## **Bid Package 02 - Construction Bulletin 05**

**05/05/2020**

**Canadian County Expo Center  
3001 Jensen Road East  
El Reno, OK 73036**

# 1 MECHANICAL DUCTWORK PLAN - AREA D

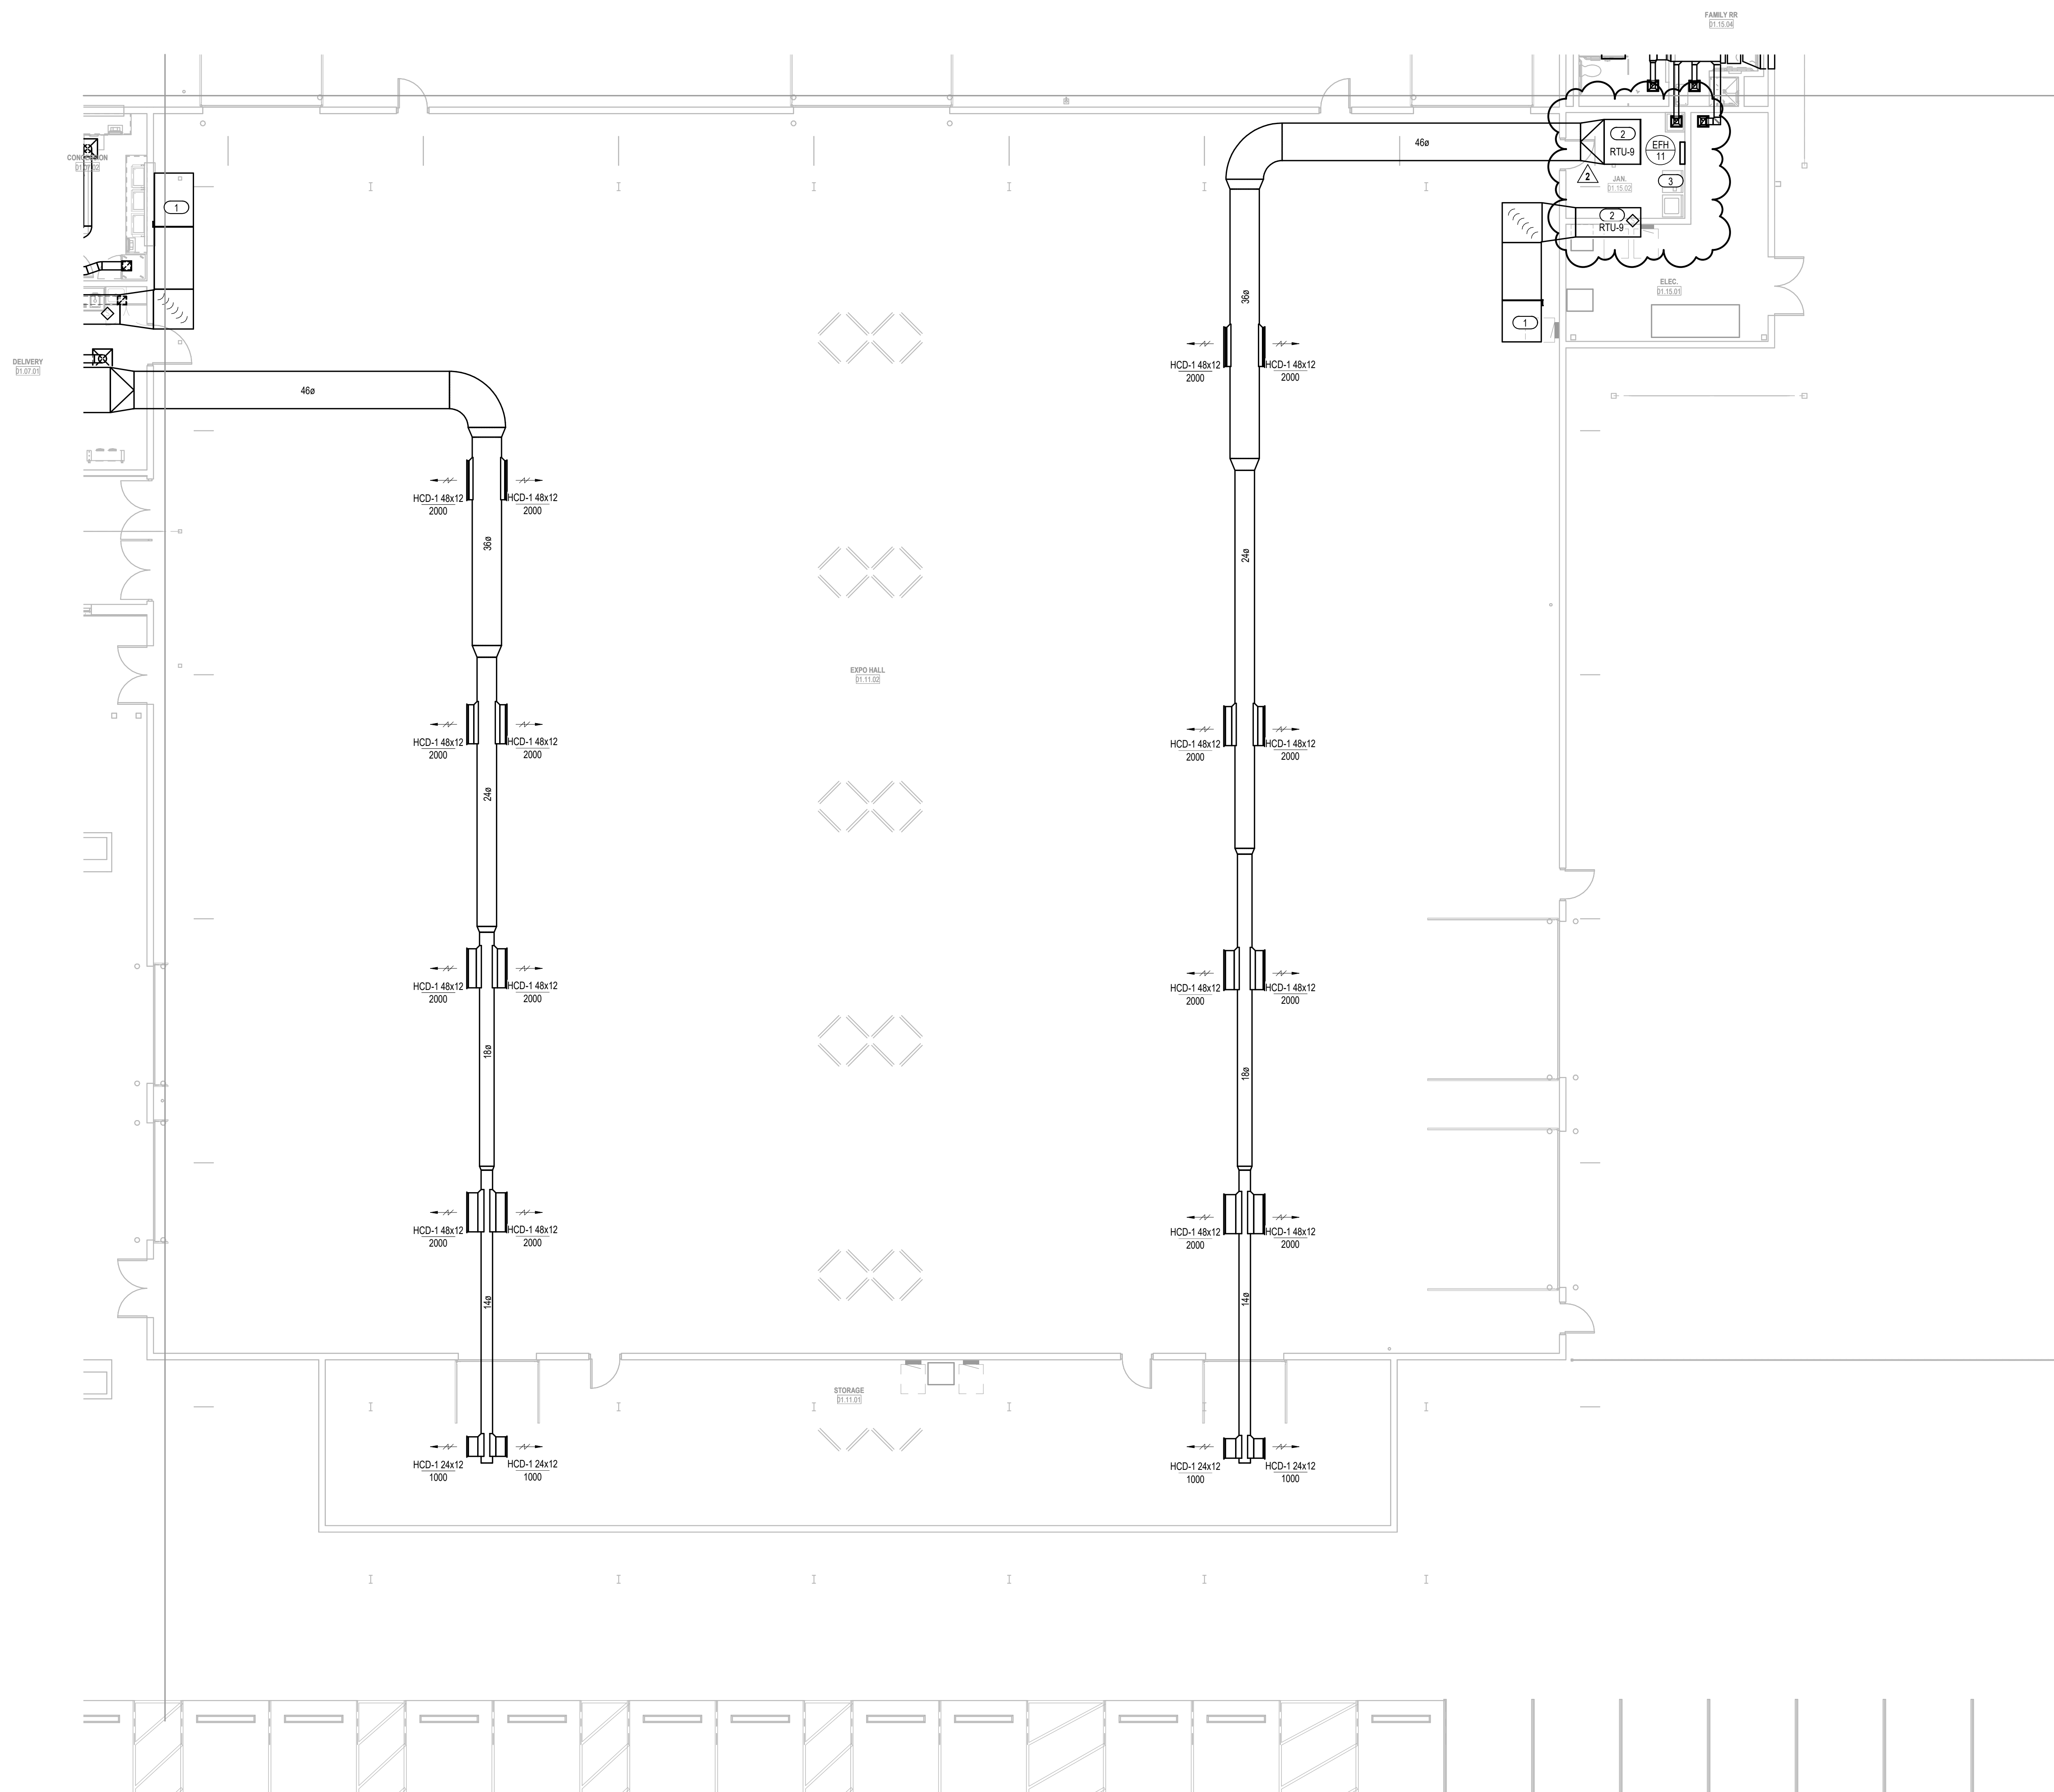
- h. Sheet M1-1D MECHANICAL DUCTWORK PLAN – AREA D
  - e. Supply and return ducts have been swapped to match unit configuration.
- i. Sheet M3-2 MECHANICAL PLAN - ROOF

- Sheet M0-2 MECHANICAL SCHEDULES SHEET
  - Packaged Rooftop Unit Schedule
    - Added staging and information.
    - Removed unused hot gas reheat note.
    - Added BACNET card requirement
  - Exhaust Fan Schedule
    - Added EF-5. This fan serves the restrooms in area A.
  - Louver Schedule
    - Added L-C for additional information for the clerestory louvers.
- Sheet M1-1a MECHANICAL DUCTWORK PLAN – AREA A
  - Shifted 14x14 duct riser that connects to EF-5 to give it 10'-0" clearance from nearby rooftop units.
- Sheet M1-1D MECHANICAL DUCTWORK PLAN – AREA D
  - Supply and return ducts have been swapped to match unit configuration.
- Sheet M3-2 MECHANICAL PLAN - ROOF
  - EF-5 has been added to the roof plan
  - L-C louvers have been added to the arena.

## 1 MECHANICAL ROOF PLAN

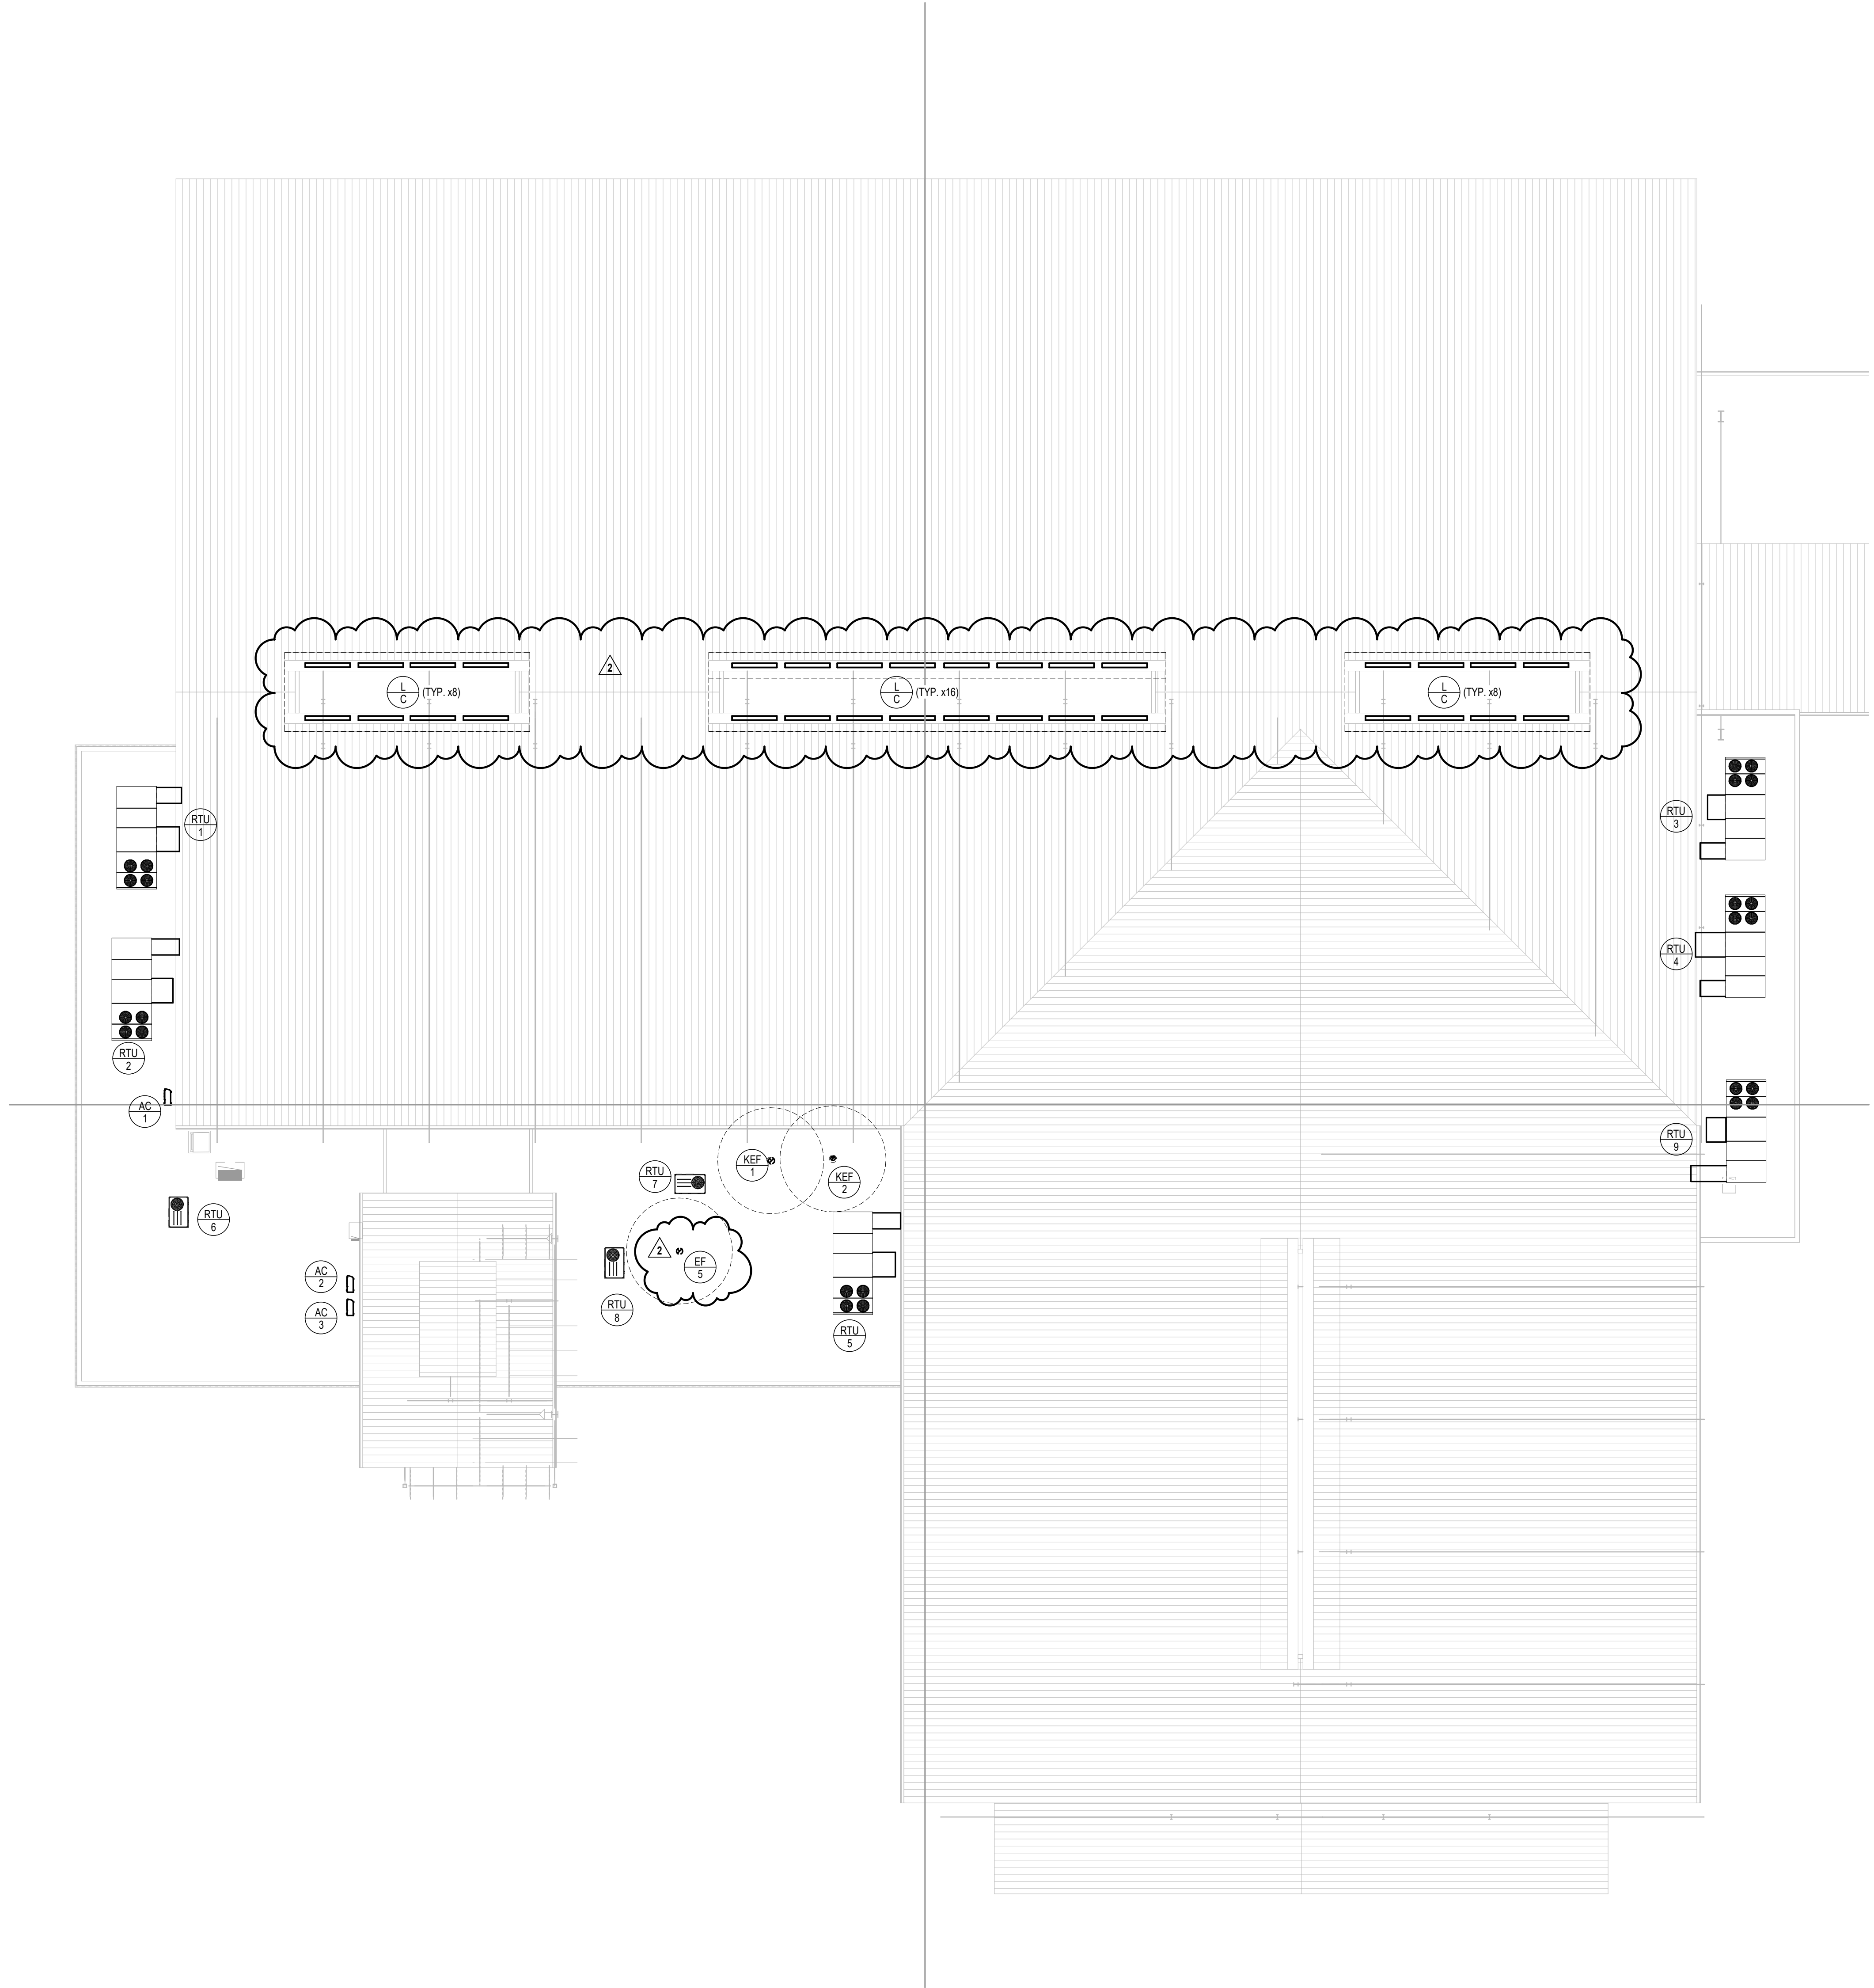
- f. EF-5 has been added to the roof plan
  - g. L-C louvers have been added to the arena.
- j. Additional approved mechanical manufacturers:
  - h. Tempmaster
